SERVICE NO. 1375C BULLETIN

**PERIODIC REPLACEMENT OF MAIN LANDING
GEAR ATTACHMENT HARDWARE**

SB 1375C revises the instructions for clarity and corrections. |

Figure 1
Main Landing Gear – Mounting Hardware

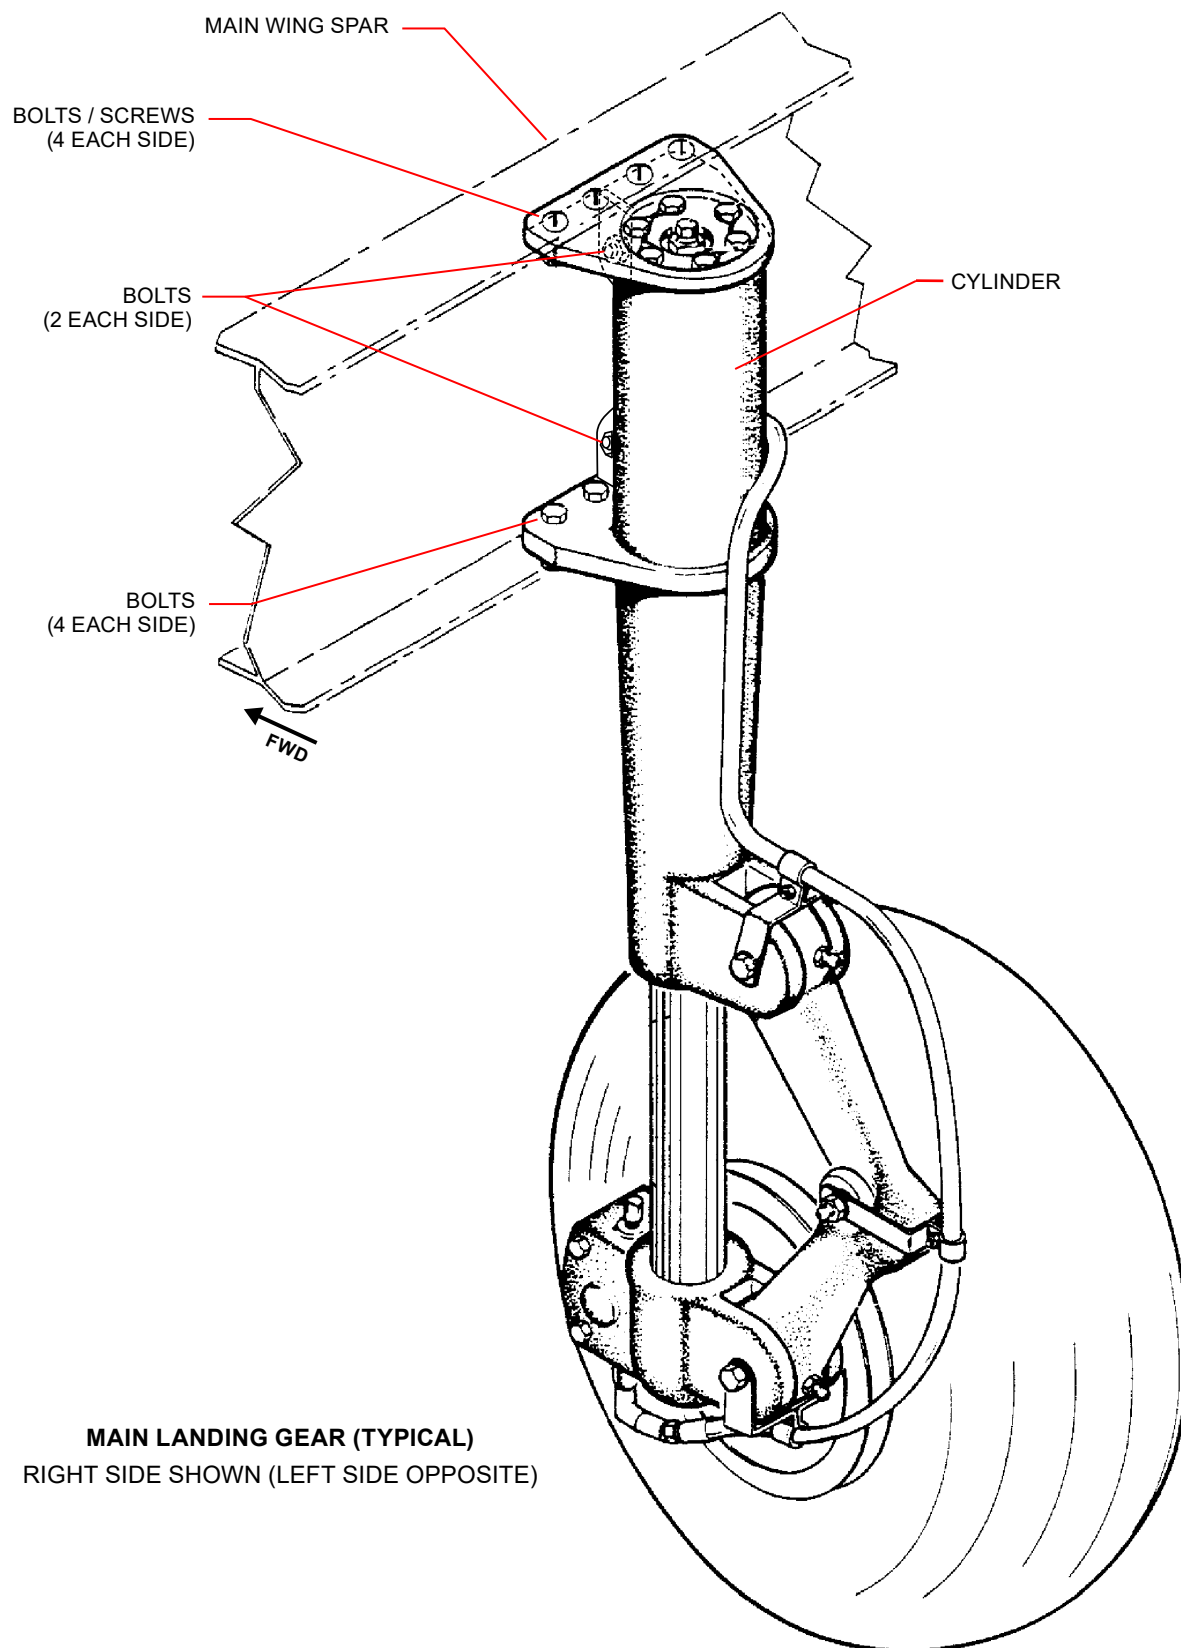
The main landing gear (MLG) is attached to the aircraft with threaded fasteners that pass through mounting flanges on the strut cylinder and the upper and lower flanges of the main wing spar, as depicted in the illustration below. On some of the affected aircraft, additional threaded fasteners pass through the web of the main wing spar.

1. Place the aircraft on jacks.
2. Remove the fairing from around the strut cylinder housing and the access plate located on the bottom of the wing and to the rear of the housing by removing attaching screws.
3. Remove the MLG and discard all of the threaded fastener stack ups (which includes screws, bolts, nuts, and washers) that attach the MLG to the main wing spar. (See Figure 1.)
4. Bolt Hole Inspection
